This is to certify that Ocean Ridge Realty Llc /n/a  
has permission to New Condominiums / Unit # 2, 3, and  
AT 840 Ocean Ave 416A A003001

Job Name: OCEAN RIDGE CONDOMINIUMS

**To:** John & Joseph Leasure                      **From:** Mike Nugent  
**Fax:** 799-5432                                      **Date:** May 1, 2003  
**Phone:** 767-4830                                 **Pages:** 1  
**Re:** Ocean Ridge units 1,2,3 & 4

**To:** Mr Mike Nugent (City of Portland Code Enforcement) **From:** JOHN LEASURE

**OCEAN RIDGE CONDOMINIUMS**  
852 OCEAN AVENUE  
PORTLAND, MAINE  
FRAMING SECTIONS AND DETAILS  
UNITS 1, 2, 3, & 4

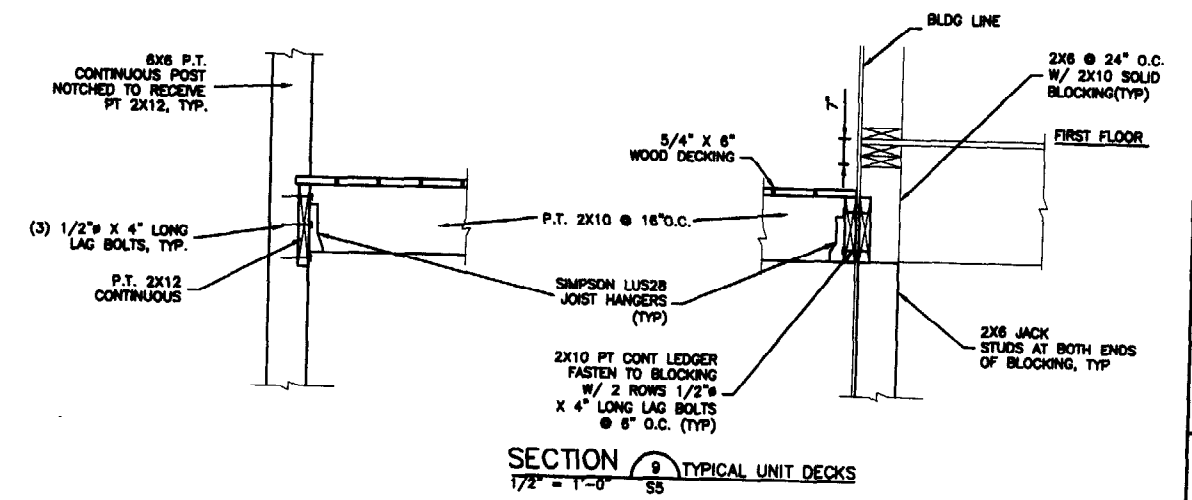
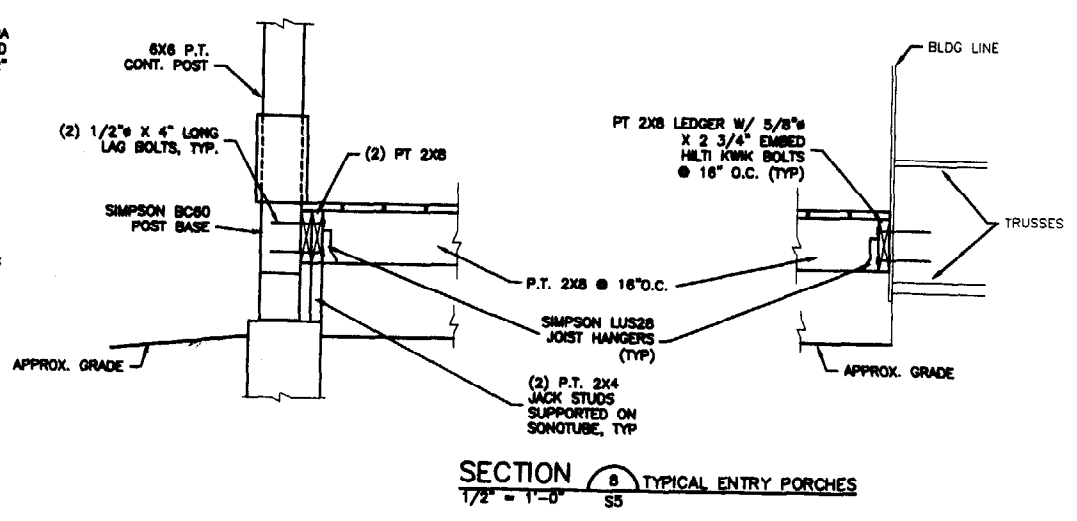
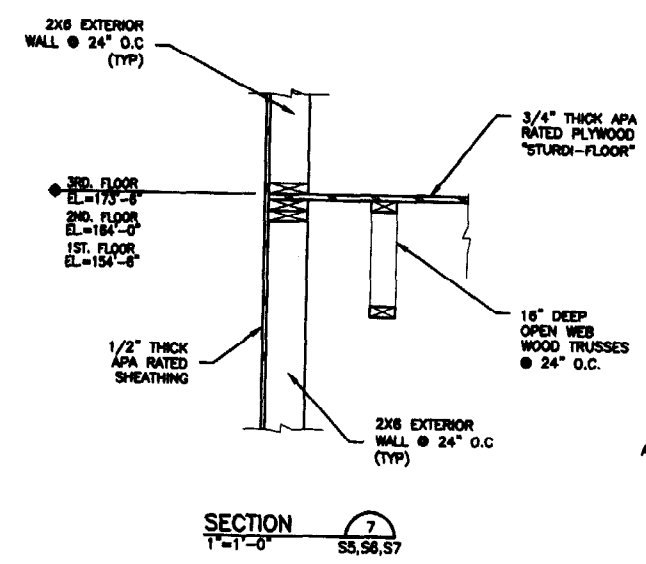
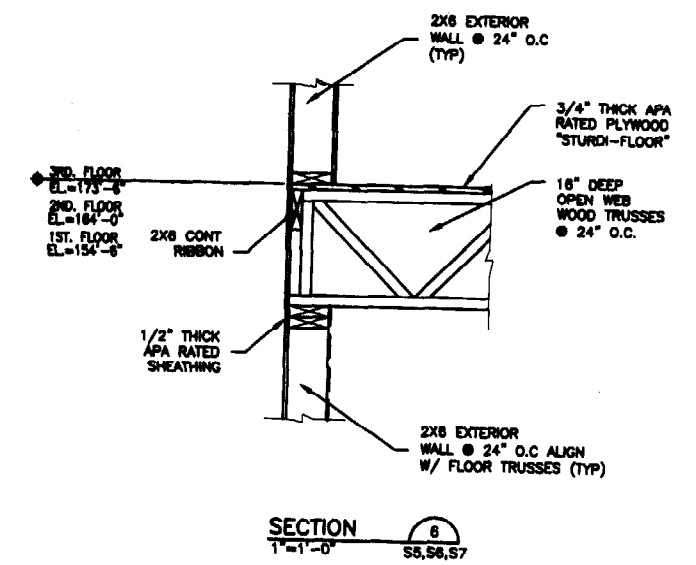
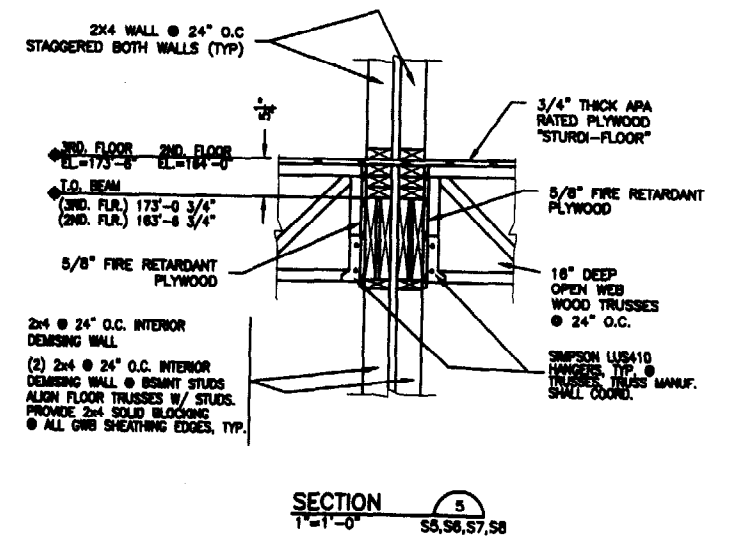
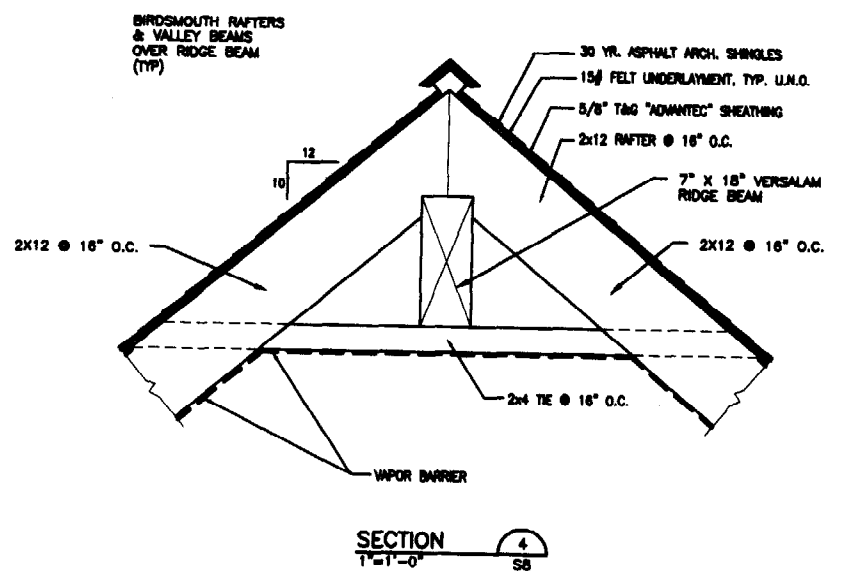
- 10) What is the STC of the wall assemblies?
  - 11) Page S9 Figure 5, using the FTW product, does the fire rated assembly include the GWB on the underside of the floor? (see section 711.4)

**OCEAN RIDGE CONDOMINIUMS**  
852 OCEAN AVENUE  
PORTLAND, MAINE  
THIRD FLOOR PLAN  
UNITS 1, 2, 3, & 4

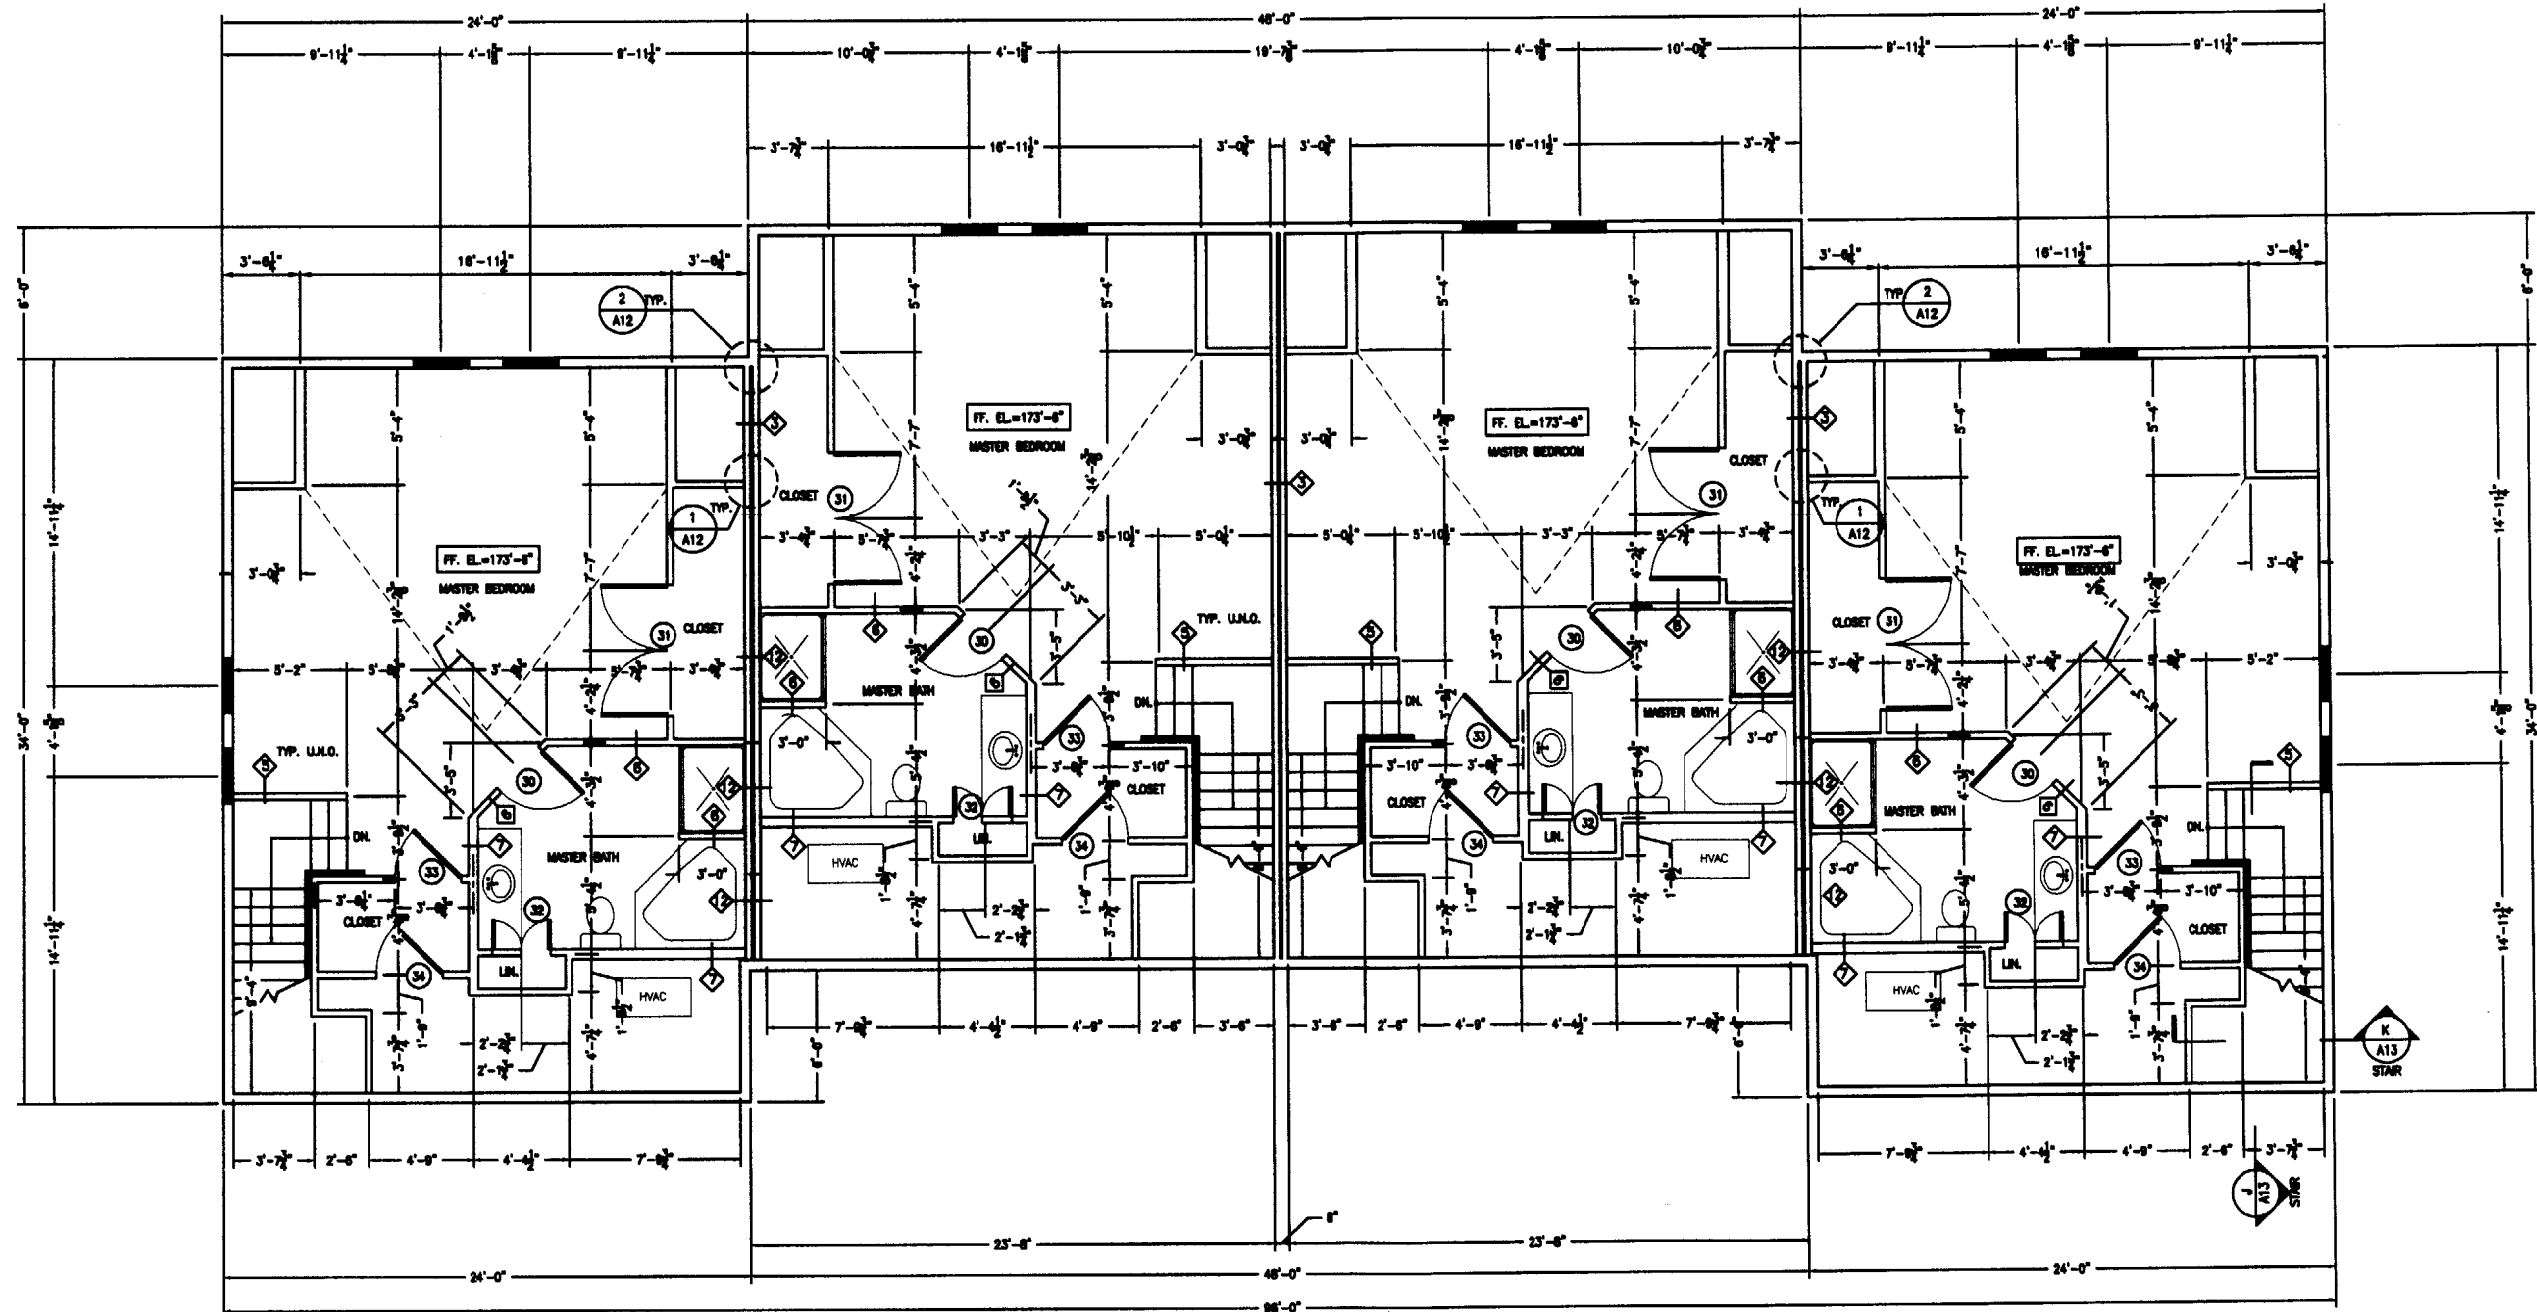
- 6) The space between the third floor ceiling joists and rafters exceeds 30 inches and no attic access is shown.
  - 7) The roof system must have a one-hour fire rating in 5A buildings.

- 6) Will provide minimum 22" x 30" opening access into the attic space. One in each dwelling unit third floor level. (BOCA 1999 Sec. 1211.2) See Dwg A4.

**OCEAN RIDGE CONDOMINIUMS**  
 862 OCEAN AVENUE  
 PORTLAND, MAINE  
 WALL TYPES & DETAILS  
 UNITS 1, 2, 3, & 4

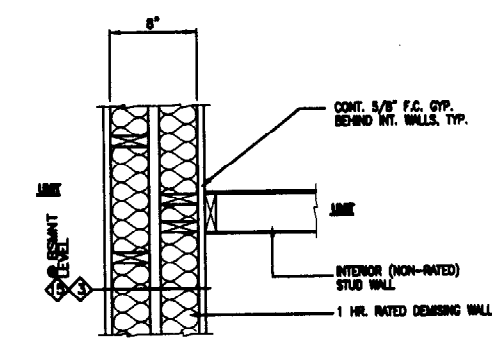
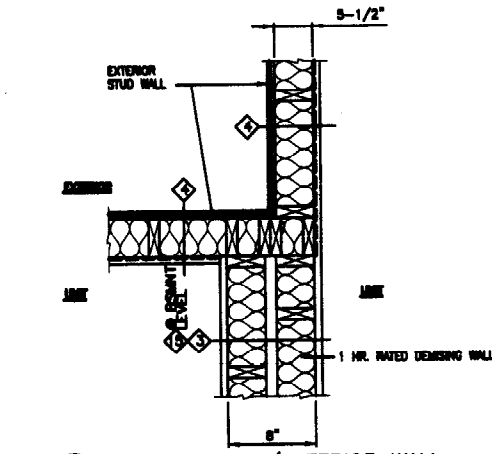
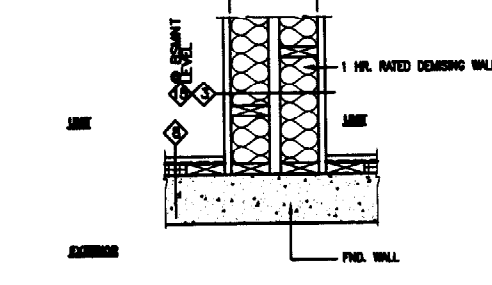
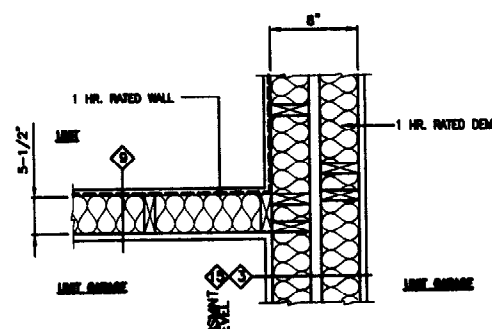
- 8) It appears that the floor ceiling assemblies need fire blocking as the space exceeds 500 Sq.ft.
  - 9) Does the wall system extend to the underside of the roof sheathing?

- 9) The Fire Rated Wall systems extends to the underside of the exterior roof sheathing typically as shown on Details1 /A9 & Detail A/A10.
- 10) The STC of the Rated Fire Wall as shown on drawing A10 is 50-55. The other walls are between 30-35 depending on insulation and sheathing materials. If you need specific wall STC documentation, please contact this office.

# DOOR SCHEDULE

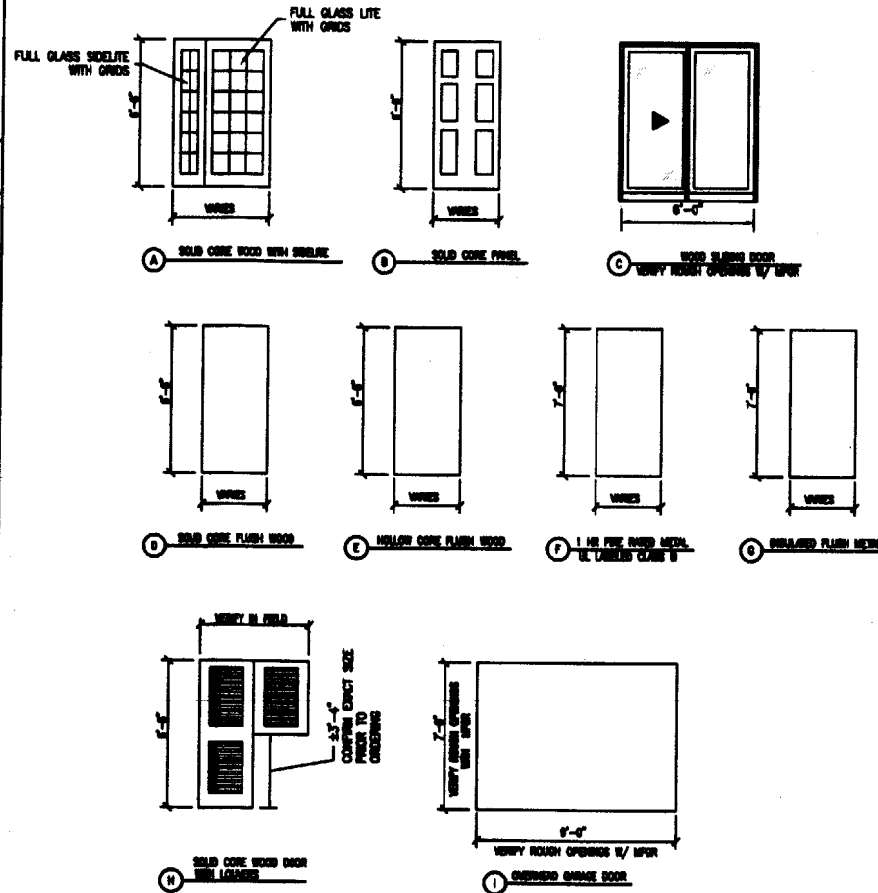
- 3) What type of Fire suppression system will be used?
  - 4) The "04" shown on page A2 is not on the door schedule, tempered glass?
  - 5) ~~require separate permits and technical info about fireplaces and heating equipment.~~
